**Community & Economic Development Division
Planning and Development Services**

To: Honorable Mayor and City Council Members
From: Katie Posler, Senior Planner KP
Through: Tim Curtis, Current Planning Director on behalf of Erin Perreault, Executive Director Planning Economic Development, and Tourism
Date: 10/21/2022
Re: 18-UP-2021 (October 25th, 2022 agenda item #16)

Stipulations for the Conditional Use Permit
For Ashler Hills Park MUMSP
Case Number: 18-UP-2021

Adopt Resolution No. 12560 approving a Municipal Use Master Site Plan for a new park on a +/- 15-acre site with Multiple-Family Residential Environmentally Sensitive Lands (R-5 ESL) zoning located at the northwest corner of E. Ashler Hills Drive and N. 74th Way (APN: 216-51-098).

Resolution No. 12560
Exhibit A to Exhibit 2
Page 2 of 2

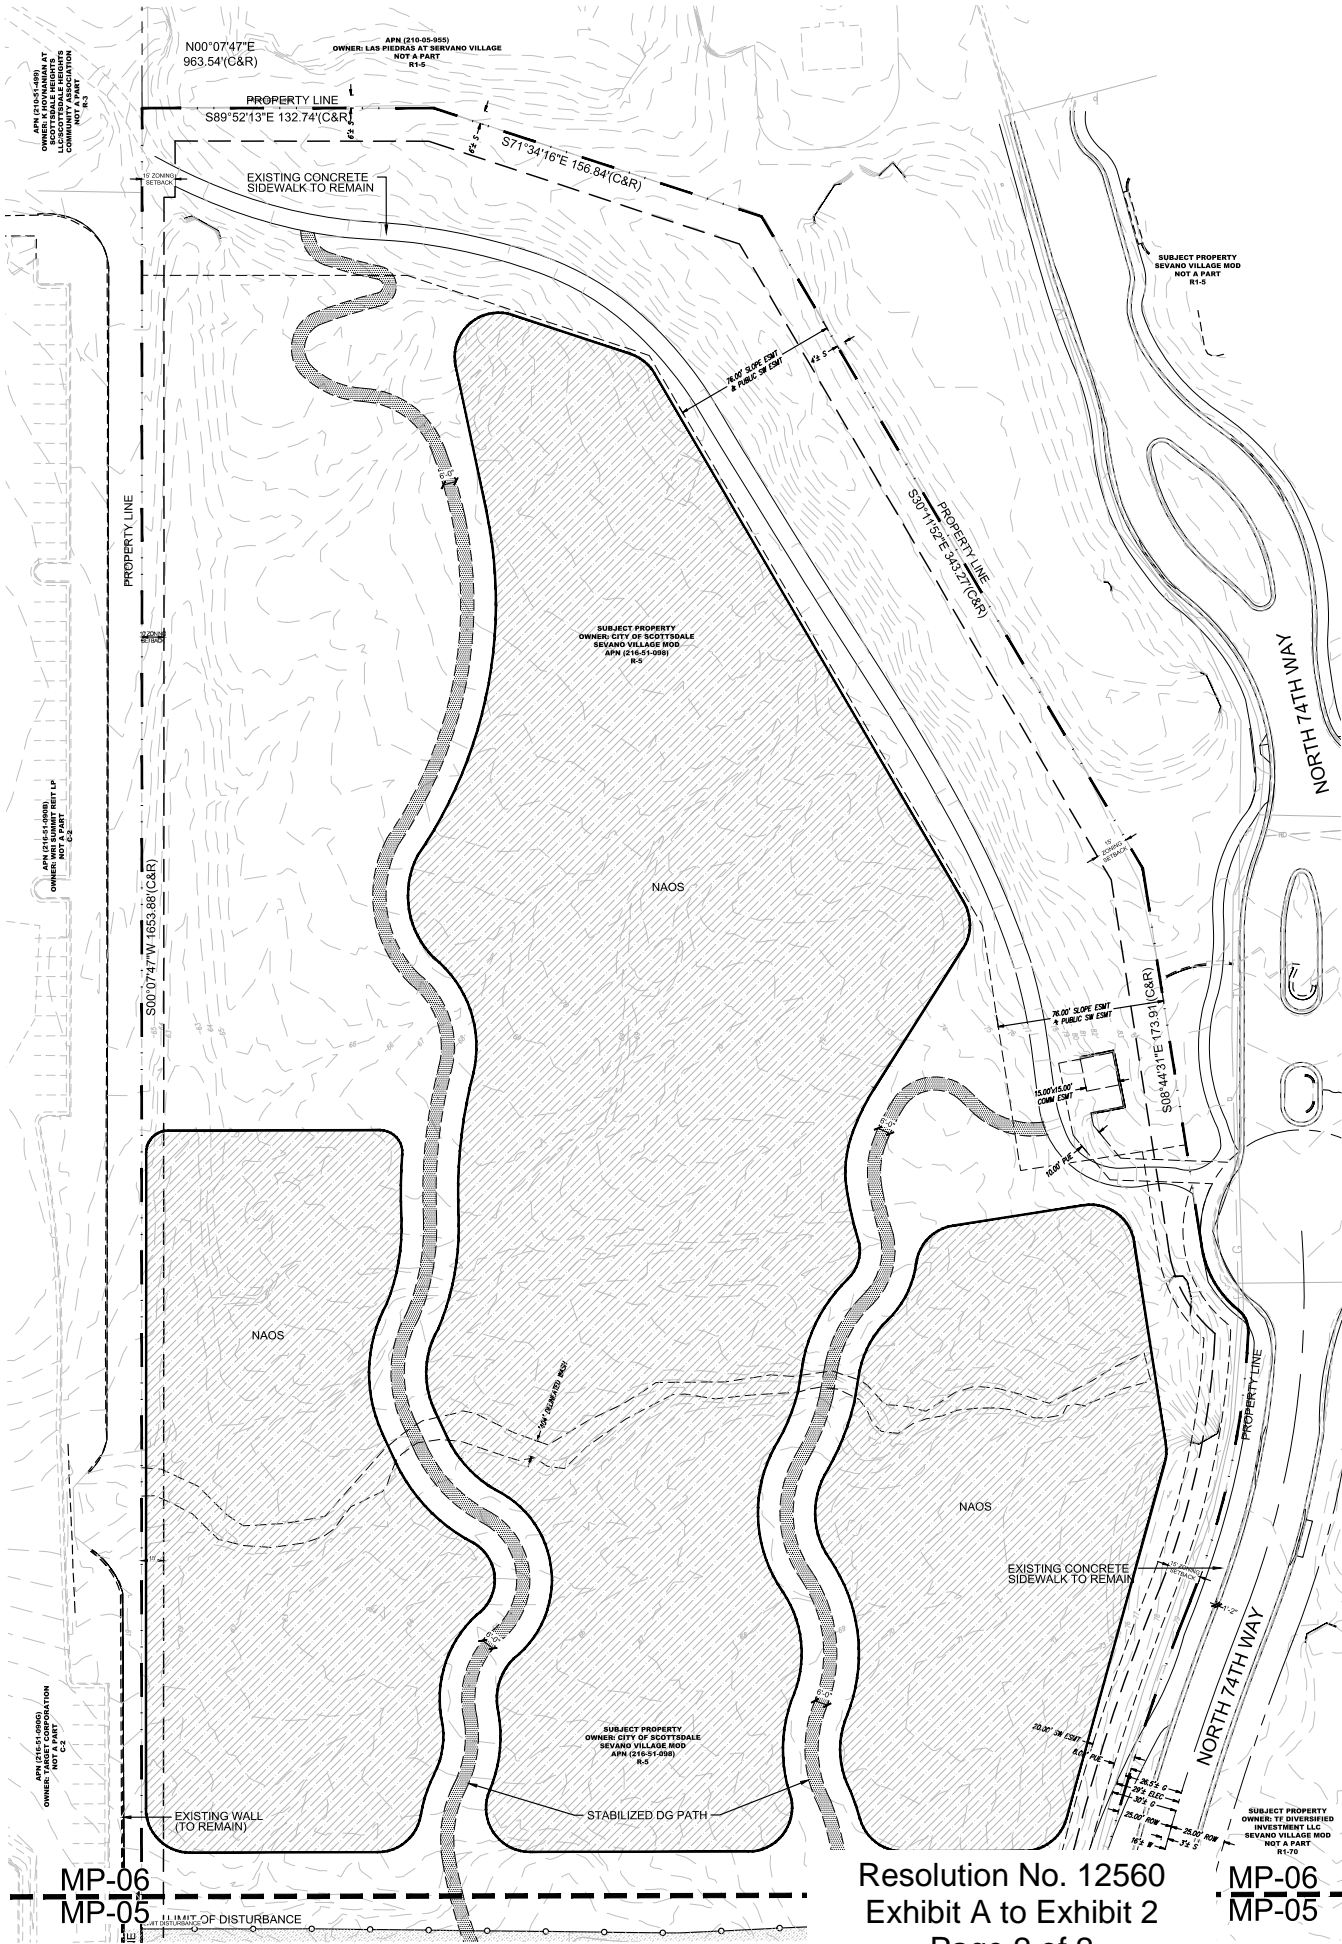
#1 - The original wording modified an existing stipulation, but this change clarifies it as a separate, additional stipulation, following the motion made by Planning Commission.

#2 - The original motion stated that proposed changes to active space and the parking entrance shall return to Planning Commission for a vote. Since the Planning Commission is a recommendation body, it should be clarified the changes would need to follow the public hearing process. This would mean presenting the proposed changes before Planning Commission for a recommendation to City Council, and then City Council determination. The change below reflects the public hearing process through the use of standard language.

1. CONFORMANCE TO CONCEPTUAL SITE PLAN. Development shall conform with the conceptual site plan, attached as Exhibit A to Exhibit 2. Any proposed significant change to the conceptual site plan, ~~SPECIFICALLY AROUND ACTIVE USE SPACE AND/OR CHANGES TO THE PARKING ENTRANCE,~~ as determined by the Zoning Administrator, shall be subject to additional action and public hearings before the Planning Commission and City Council.

9. ACTIVE SPACE AND PARKING ENTRANCE. PROPOSED CHANGES TO THE SITE PLAN, SPECIFICALLY AROUND ACTIVE USE SPACE AND/OR CHANGES TO THE PARKING ENTRANCE, SHALL BE SUBJECT TO ADDITIONAL ACTION AND PUBLIC HEARINGS BEFORE THE PLANNING COMMISSION AND CITY COUNCIL.

Figure 6 – 2022 Total Traffic Volumes

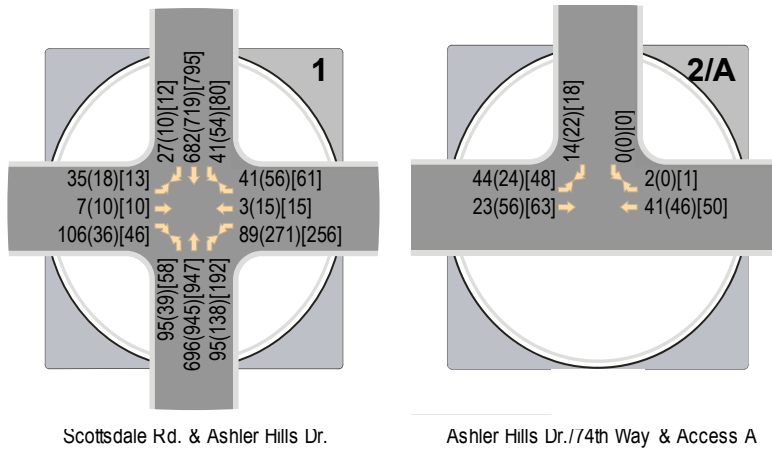
- d. Finally, there is a potential point of confusion with respect to total daily traffic volume on the east leg of the Scottsdale Road-Ashler Hills Drive intersection. Figure 6 in TIS 5/31/22 replaces Figure 5 in TIS 5/21/21². The figures look very similar on first glance. However, Figure 6 reflects trips east of 73rd Street, while Figure 5 reflects trips west of 73rd Street, i.e., between 73rd Street and the Scottsdale.*

- The previous (5/21/21) Figure 5 indicates the total daily along Ashler Hills Drive **west** of the commercial driveway. As expected, commercial driveways are anticipated to generate more trips. The recent (5/32/22) Figure 6 shows the total daily traffic east of 73rd Street (per request from the City) so as separate the commercial driveway traffic from the residential traffic on Ashler Hills Drive. Furthermore, the total daily between the two locations summarized significant differences in trips at the two different locations. Figure 5 will be modified to show both volumes.

² Figure 6 has two errors: it should read 817 westbound trips and 834 eastbound trips. TIS 5/31/22 has other errors as well. For example, Attachment H is omitted and Attachment I includes pages from the 2010 DSPM.

e. Scottsdale Road-Ashler Hills Drive intersection. Below is a new Figure 5, updated to reflect how it would have appeared in TIS 5/31/22, namely, by a) applying the specified 1% annual growth rate to the traffic counts west of 73rd Street (TIS 5/21/21 page 14) and b) adding the projected east development trips. By May 2023, 1% more trips are expected to be added to the traffic volume.

Figure 1. One-half mile radius from park site (shaded red)

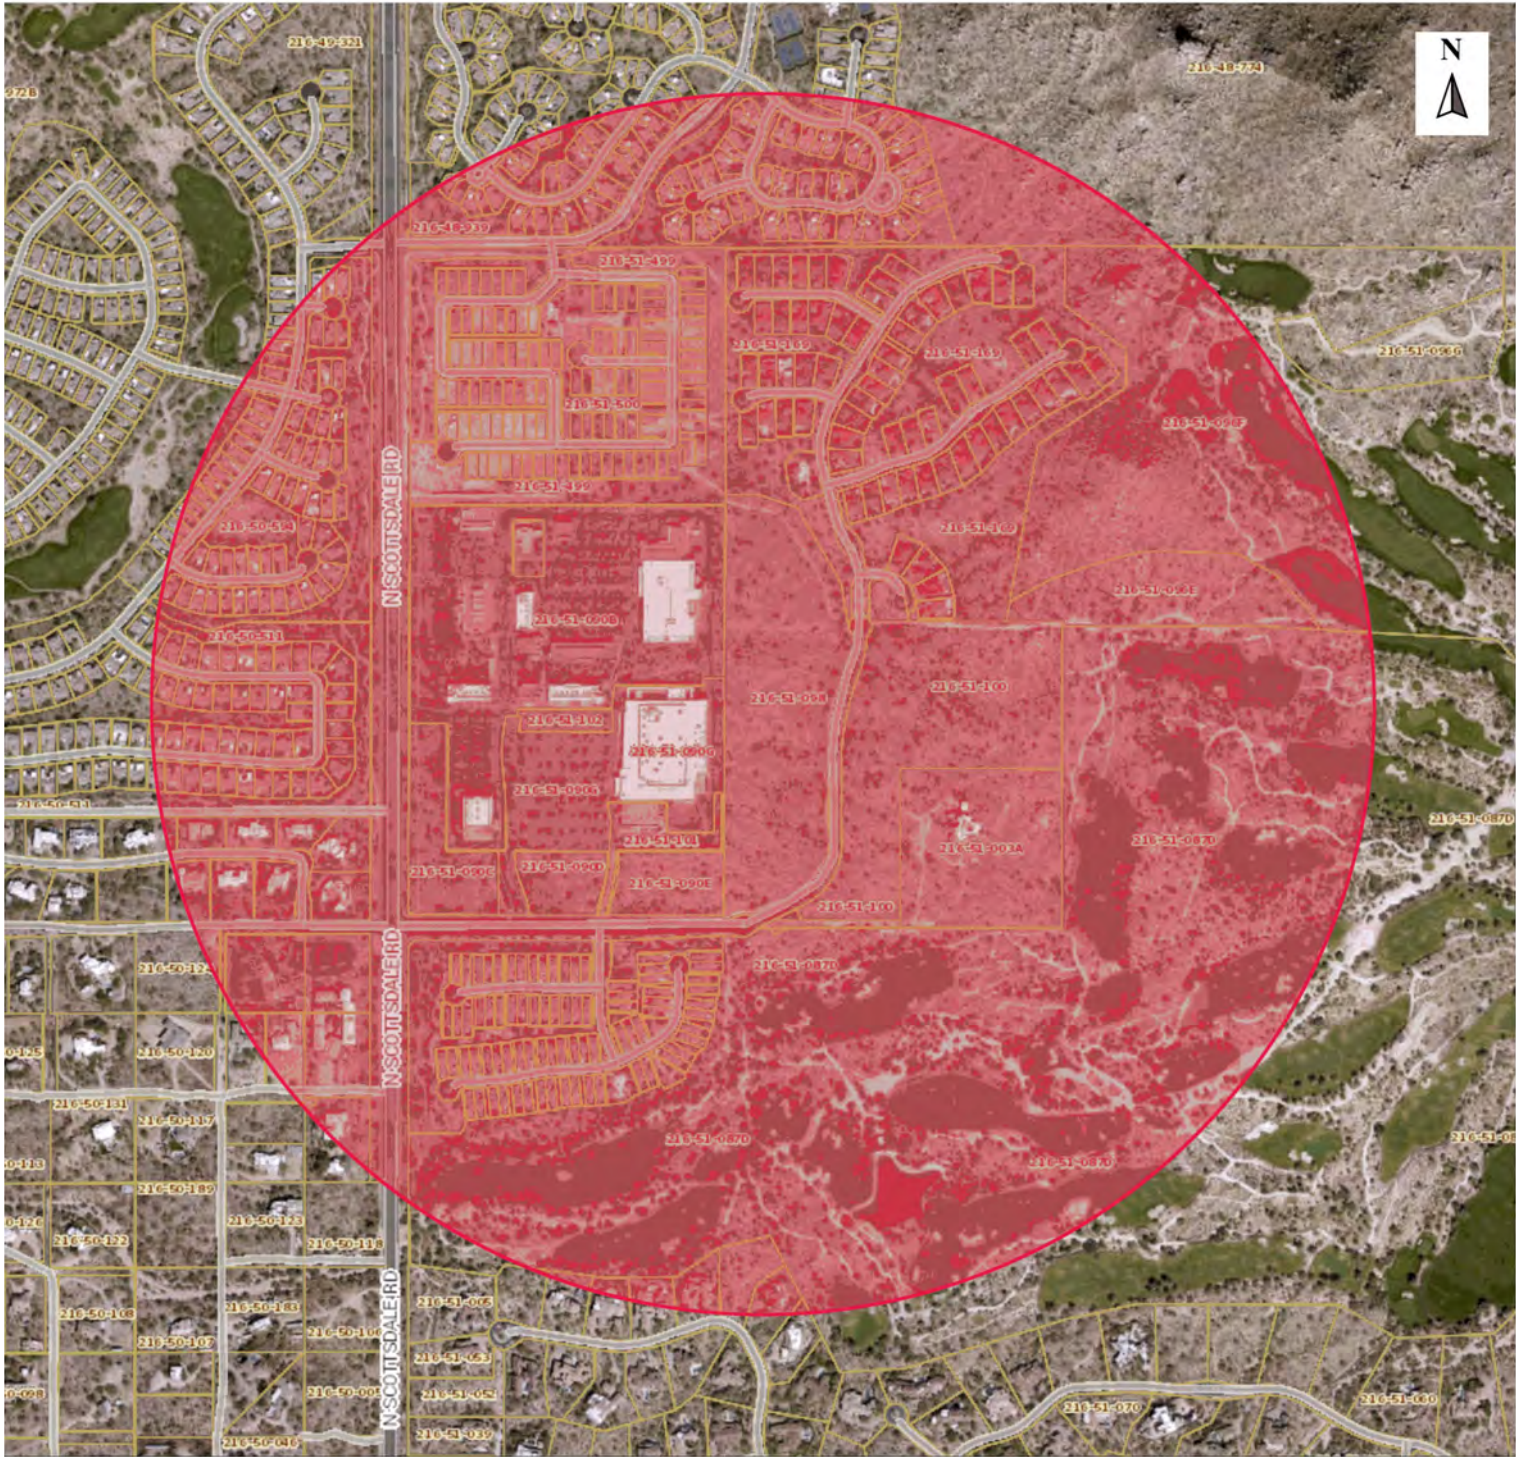
Accordingly, when planning the development of a new Neighborhood Park, the City is to consider the recreational needs and preferences of residents within a one-half (½) mile radius (Figure 1 attached).

Our community, Las Piedras, will be directly and significantly impacted by the development of Ashler Hills Park. The park parcel is contiguous with our southwestern border. The park parcel extends 490 feet – nearly one-third of its total length – "into" our community (Figure 2 attached). The park parcel is only 160 feet from the nearest home in Las Piedras. Ten homes are within 300 feet.

Any park development that occurs in the orange-shaded area of Figure 2 is virtually within our community. We appreciate that, in the current proposed site plan, "improvements" in this area are limited to the loop trail and existing path. We note that this area is in keeping with a designated focus of Neighborhood Parks: to preserve open spaces (Community Services Master Plan 2015). In addition, undisturbed portions of this area may count toward the development's Natural Area Open Space (NAOS) requirement.

Figure 6. Blind curve safety hazard at City's proposed access (park entrance)

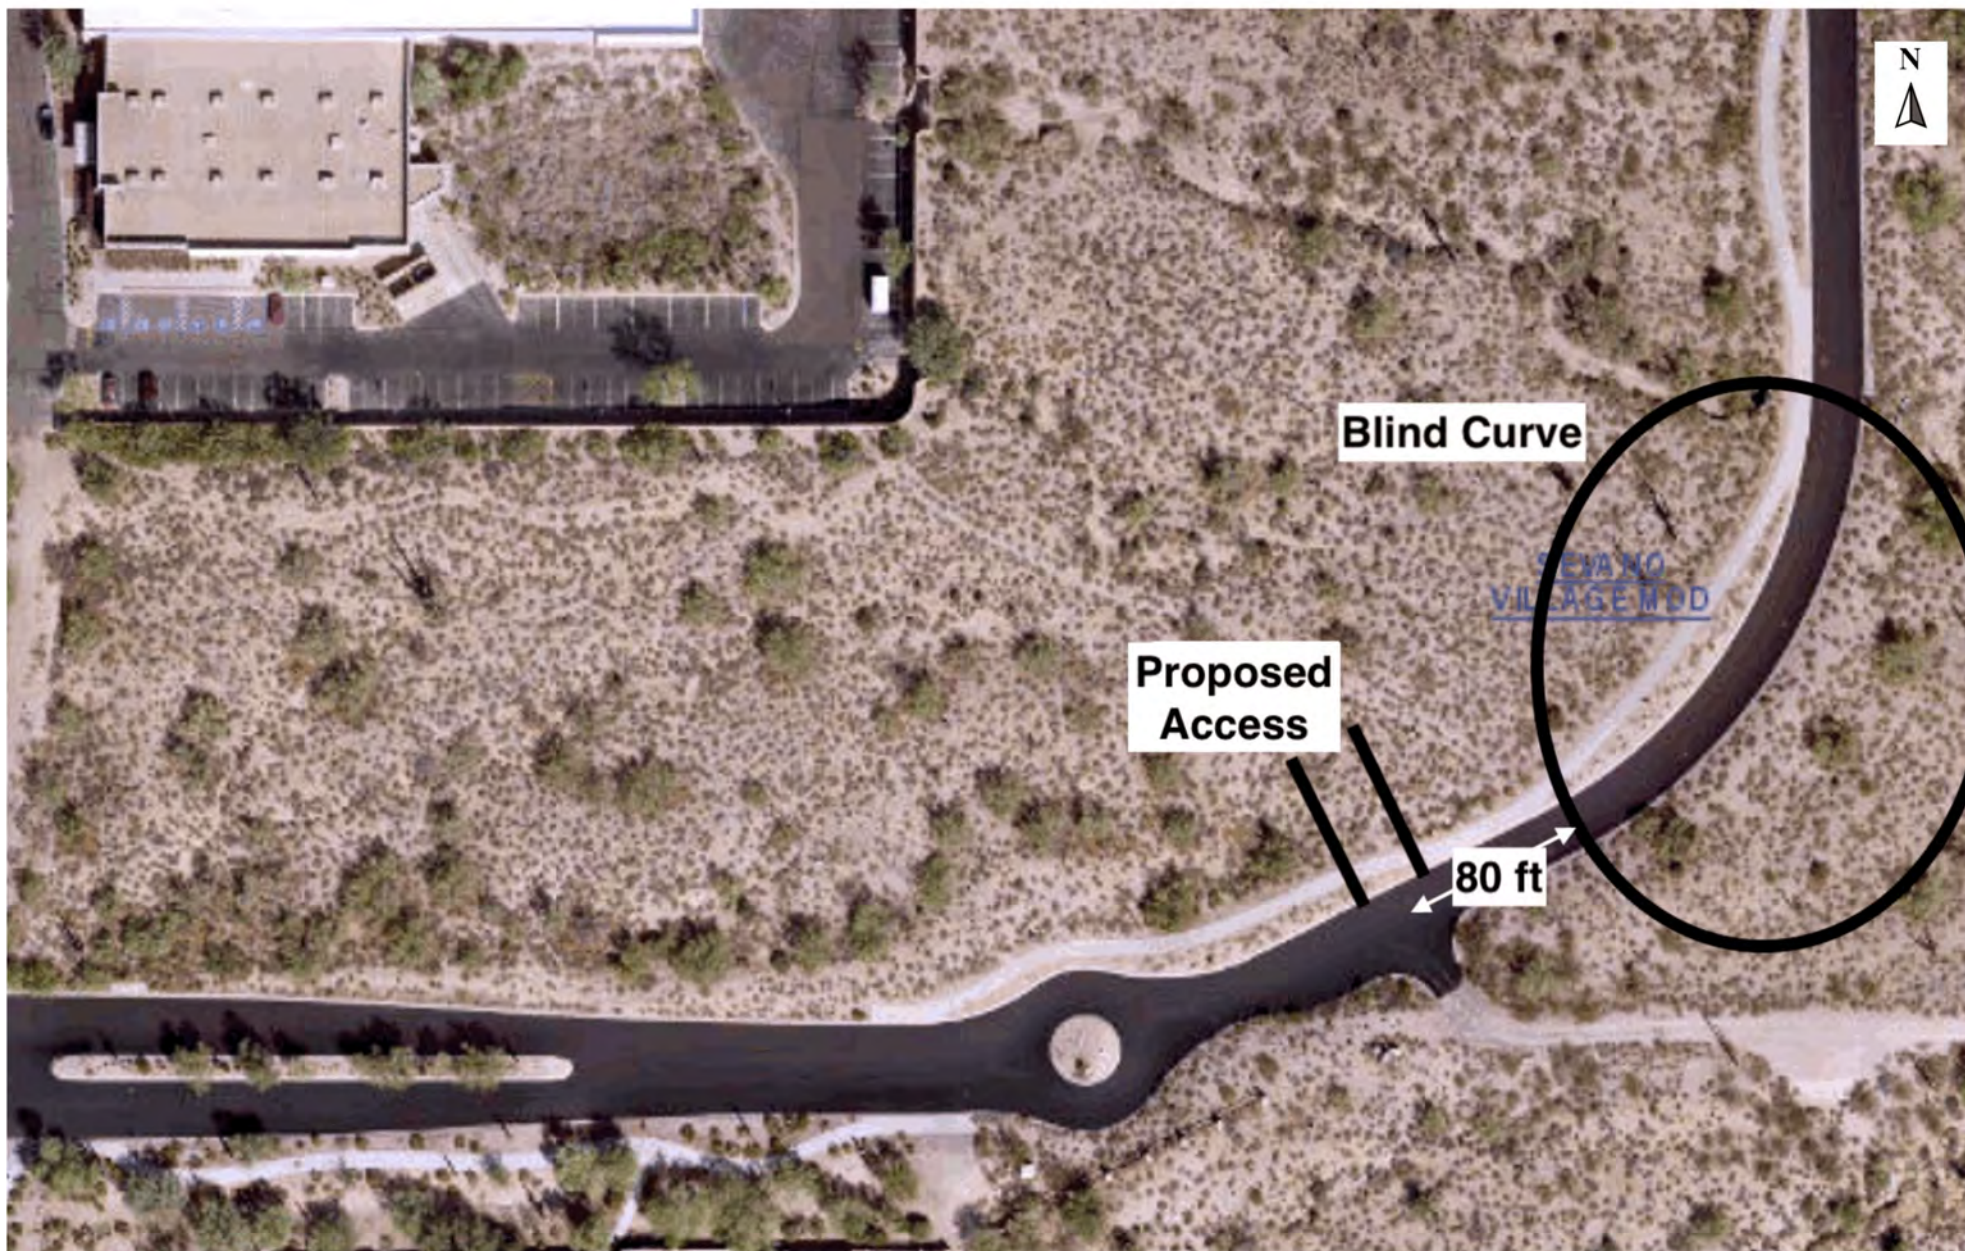
At the park site, east-west Ashler Hills Drive turns to become north-south 74th Way. The northeast portion of that long turn has the shortest radius of curvature; this sharp curve is a blind curve (Figure 6 attached).

Accordingly, Las Piedras suggests an alternative location for the park access ("alternative access location") (Figure 7 attached). This location is far superior for the following reasons:
